APPLICATION NUMBER(S)	RZ 25-05 Rezoning
	SP 25-05 Site Plan
	MAJ SD 25-02 Preliminary Plat
APPLICATION NAME:	Collinsville Landing
APPLICANT NAME:	AKG Development (Bijou Creek Capital, LLC) 34 N Brentwood Blvd. Suite 201 St. Louis, MO, 63105
PROPERTY OWNER NAME(S):	Bijou Creek Capital, LLC 34 N Brentwood Blvd. Suite 201 St. Louis, MO, 63105
APPLICANT'S REQUEST:	A request by Bijou Creek Capital, LLC, property owner, to rezone fifteen (15) parcels located along N Bluff Road, Beverly Lane and Ostle Drive from "R-1", "B-2" and "B-3" Districts to "P-CP-1" Planned Commercial Park District coupled with Preliminary Plat and Site Plan approval to permit development of Collinsville Landing, five (5) building commercial development of restaurants and personal services.
SITE ADDRESS(S):	North Bluff Road, Beverly Lane & Ostle Drive
PARCEL ID NUMBER(S)	13-1-21-29-15-401-003; -019; -020, 13-2-21-29-15-401-004; -005; -005.001; -006; -007; -008; 009; 010; -011; -012; -013; -030

Existing Zoning District(s):	"R-1" Single Family Residential and "B-2" Limited Commercial & "B-3" Expressway Commercial District
PROPOSED ZONING DISTRICT(S):	"P-CP-1" Planned Commercial Park District
TOTAL SITE AREA:	11.076

Beverly Realignment:

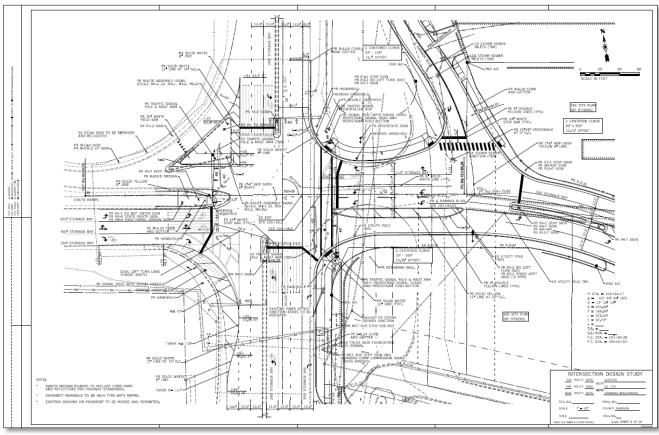
The IDS includes design for the realignment of Beverly Lane as seen below. This includes a stop for the northbound traffic lane at the new curve for vehicles making a left turn into the Chiptole site as well as a stop at the intersection of Ramada and the pedestrian crossing.

Collinsville Landing: Preliminary Plat

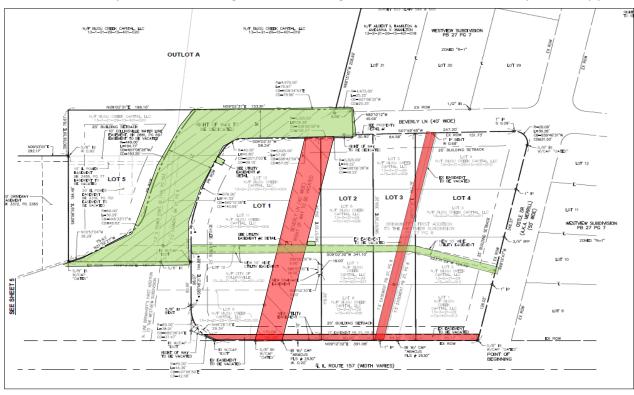
The gross area of the site is 11.076 acres. 4.58 acres to be developed, 0.698 acres in new right-of-way and 5.74 acres undeveloped in Outlot A. The preliminary plat includes vacating existing easements no longer to be used including the 7.5' wide easement for overhead electric previously servicing the residential properties and the existing Beverly Lane 40' wide right-of-way. The preliminary plat dedicates new easements for the development including a 10' wide utility easement running North and South along the property, a drainage easement to access the basins and two utility easements for service.

Below in red are major easements being removed and in green new easements with the preliminary plat.
